Title of Change:	D2PAK Case Outline Standardization from 418B-04 to 418AJ for all effected devices manufactured in On Semiconductor Seremban, On Semiconductor Vietnam and TFME facility.	
Proposed Changed Material First Ship Date:	14 June 2020 or earlier upon customer approval	
Current Material Last Order Date:	NA Orders received after the Current Material Last Order Date expiration are to be considered as orders for new changed material as described in this PCN. Orders for current (unchanged) material after this date will be per mutual agreement and current material inventory availability.	
Current Material Last Delivery Date:	NA The Current Material Last Delivery Date may be subject to change based on build and depletion of the current (unchanged) material inventory.	
Product Category:	Active components – Discrete components	
Contact information:	Contact your local ON Semiconductor Sales Office or <Norsahida.sahman@onsemi.com>

文書番号 : FPCN22500Z

発行日 : 14 June 2019

D²PAK 3
CASE 418B-04
ISSUE L

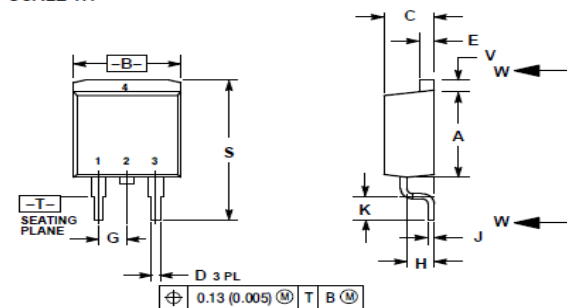
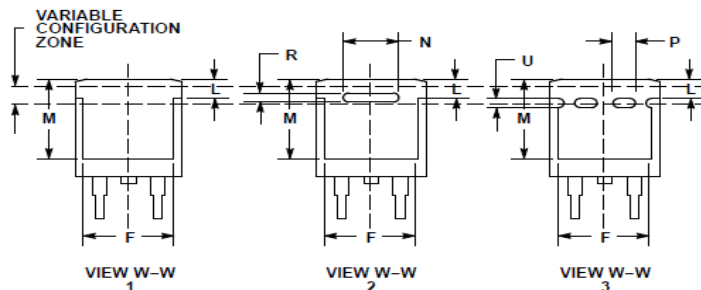
Change Category	Type of Change	
Data Sheet	Change of datasheet parameters/electrical specification (min./max./typ. values) and/or AC/DC specification	
Description and Purpose:		
ON Semiconductor is migrating the D2PAK discrete package case outline from version 418B-04 to version 418AJ. The change impacts the Rectifier, BJT and MOSFET product lines. This transition allows ON Semiconductor to standardize its significantly increased portfolio on a single case outline. This notification does not represent a change to existing materials, tools or processes used to manufacture the affected devices. The new case outline, 418AJ, is consistent with JEDEC dimensional guidelines for the D2PAK. There are no product material changes as a result of this change. There is no product marking change as a result of this change.		
	Before Change Description	After Change Description
Case Outline	418B-04	418AJ

D²PAK-3 (TO-263, 3-LEAD)
CASE 418AJ
ISSUE C

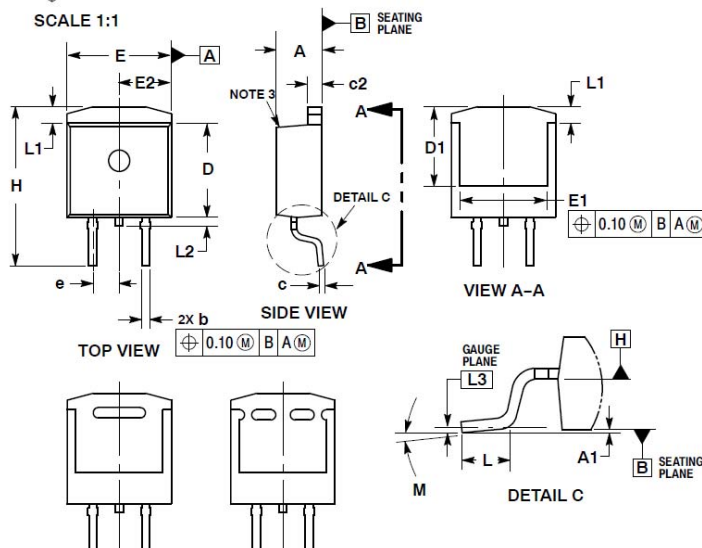
Reason / Motivation for Change:	Case outline standardization for D2PAK discrete package.	
Anticipated impact on fit, form, function, reliability, product safety or manufacturability	The device has been qualified and validated based on the same Product Specification. The device has successfully passed the qualification tests. Potential impacts can be identified, but due to testing performed by ON Semiconductor in relation to the PCN, associated risks are verified and excluded. No anticipated impacts.	
Sites Affected:	ON Semiconductor Sites: ON Seremban, Malaysia ON Dong Nai Province, Vietnam	External Foundry/Subcon Sites: TFME
Marking of Parts/ Traceability of Change:	Not applicable	
Reliability Data Summary: There is no reliability data as this change does not involve change on the final product. Only change the case outline specification in datasheet only.		
Electrical Characteristic Summary: Electrical characteristics are not impacted.

D²PAK 3
CASE 418B-04
ISSUE L

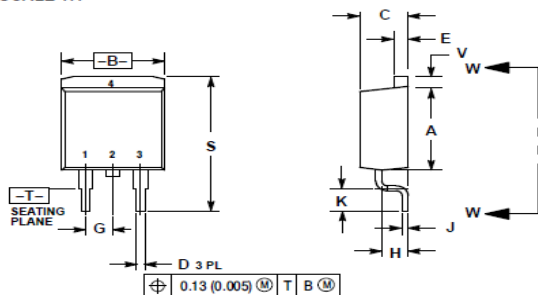
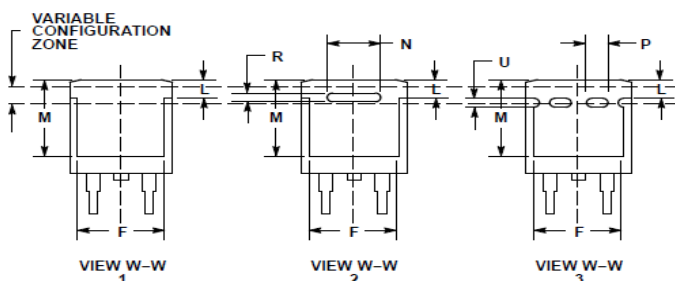
オン・セミコンダクターは、D2PAK ディスクリートパッケージのケースアウトラインを、バージョン 418B-04 からバージョン 418AJ に移行します。この変更は、整流器、BJT、および MOSFET 製造ラインに影響を与えます。この移行により、オン・セミコンダクターは大幅に増大したポートフォリオを単一のケースアウトラインに標準化できます。

変更前の表記	変更後の表記
ケースアウトライン	418B-04	418AJ

D²PAK-3 (TO-263, 3-LEAD)
CASE 418AJ
ISSUE C

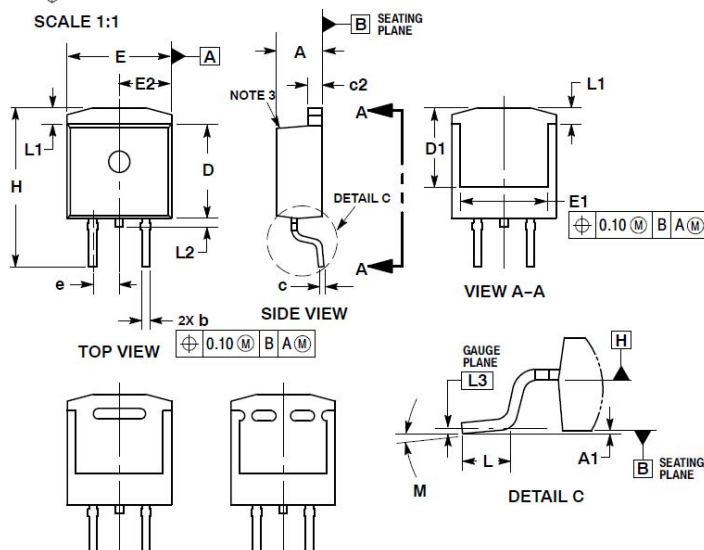
この通知は、対象製品の製造に使用される既存の材料、ツール、またはプロセスへの変更を意味するものではありません。新しいケースアウトラインの 418AJ は、D2PAK の JEDEC 寸法ガイドラインに適合しています。

変更の理由 / 動機:	D2PAK ディスクリートパッケージのケースアウトライン標準化	
適合性、形状、機能、信頼性、製品安全性、または製造可能性に関して見込まれる影響	デバイスと同じ製品仕様に基づいて認定および検証されています。デバイスは認定試験に正常に合格しています。潜在的な影響が確認される可能性があります、オン・セミコンダクターが PCN に関して実施する検査により、関連するリスクは検証および排除されます。 予想される影響はありません。	
影響を受ける拠点:	オン・セミコンダクター拠点: ON Seremban, Malaysia ON Dong Nai Province, Vietnam	外部製造工場 / 下請業者拠点: TFME
部品の表示 / 変更の追跡可能性:	該当なし	
信頼性データの要約:		
この変更は最終製品における変更と無関係なため、信頼性に関するデータはありません。データシートだけのケースアウトライン規格のみの変更です。		
電気的特性の要約:		
電気的特性への影響はありません。		
影響を受ける部品の一覧:		
注: 標準の部品番号(既製品)のみが部品一覧に記載されます。 本 PCN に影響を受けるカスタム 部品は、PCN メールの顧客の特定の PCN の付属文書、または PCN カスタマイズポータルに記載されています。		
現在の部品番号	新部品番号	認定試験用ピークル
NBRB8H100T4G	NA	NRVBB41H100CTT4G
NGB15N41ACLT4G	NA	NRVBB41H100CTT4G
NGB18N40ACLB4G	NA	NRVBB41H100CTT4G
NGB8202ANTF4G	NA	NRVBB41H100CTT4G
NGB8204ANT4G	NA	NRVBB41H100CTT4G
NGB8207ABNT4G	NA	NRVBB41H100CTT4G
NGB8207BNT4G	NA	NRVBB41H100CTT4G
NGB8245NT4G	NA	NRVBB41H100CTT4G
NJBUB323ZT4G	NA	NRVBB41H100CTT4G
NJVMJB41CT4G	NA	NRVBB41H100CTT4G
